MEMORANDUM

To: Development Review Board
From: Mary O'Neil, AICP, Principal Planner
Date: October 16, 2018 continued hearing.
RE: ZP18-0894LL / AP 14 Peru Street and
ZP18-0895LL / AP 16 Peru Street

Request: Appeal of an administrative denial of a boundary line adjustment between 14 and 16 Peru Street.

Google Street view, taken October 2014. Note appearance of 16 Peru prior to alterations, and narrow width of 14 Peru Street driveway.

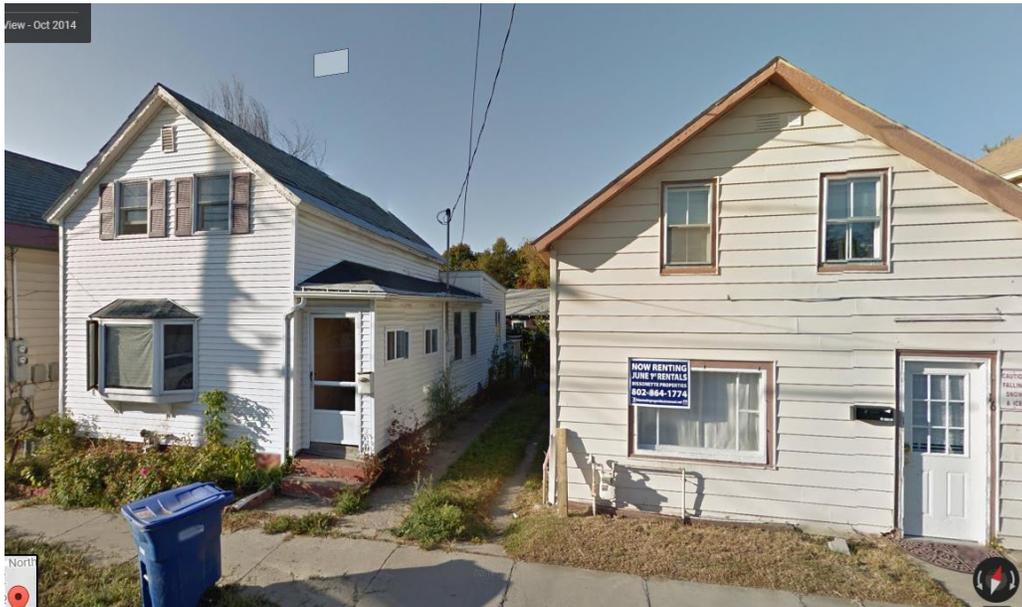
The proposed lot line adjustment conflicts with Section 6.1.2 (c) in that the proposed lot line is not perpendicular or radial to the street right-of-way line, and does not perpetuate the existing development pattern of rectangular parcels. **Adverse finding.**

The proposed lot line adjustment creates or increases several non-conformities (including those of dimensional standards, setback, and minimum parking standards) and conflicts with the noted standards of Articles 4, 5, 6, 8 and 10. No variance has been approved by the DRB. Approval of the proposed boundary line adjustment is therefore not possible.
